Seal on Mirror Attachment Point Wrinkled: Replacing Spacer Between Mirror Attachment Point and Door Seal (212/21)

Vehicle Type: **911 Turbo (992)/911 GT3 (992)**

Model Year: **As of 2021 up to 2022**

Position of spacer and felt strip

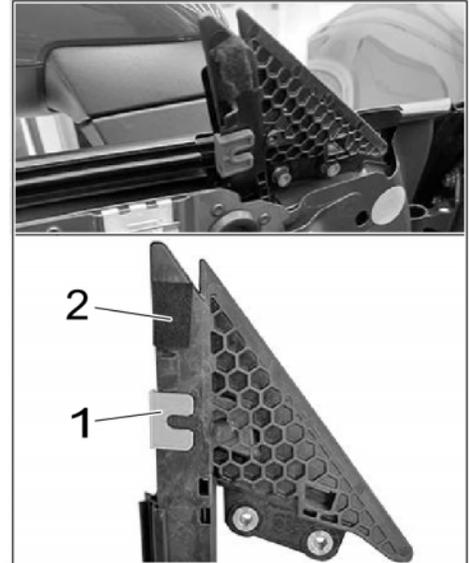
Information: Customers are complaining that the door seal on the mirror attachment point wrinkles. This is caused by the lightweight shims, which are thicker and sharper than the safety glass (ESG). As a result, the door seal will spring up when the lightweight shims close.
The fault type can occur on the driver's and/or passenger's side.

Action required: Insert a spacer between the mirror attachment point and door seal to prevent the problem from occurring again.

Work Procedure: 1 Install spacer ⇒ *Position of spacer and felt strip -1-* underneath the lug as shown in ⇒ *Position of spacer and felt strip* .
2 Affix felt strips ⇒ *Position of spacer and felt strip -2-* above the lug as shown in ⇒ *Position of spacer and felt strip* .
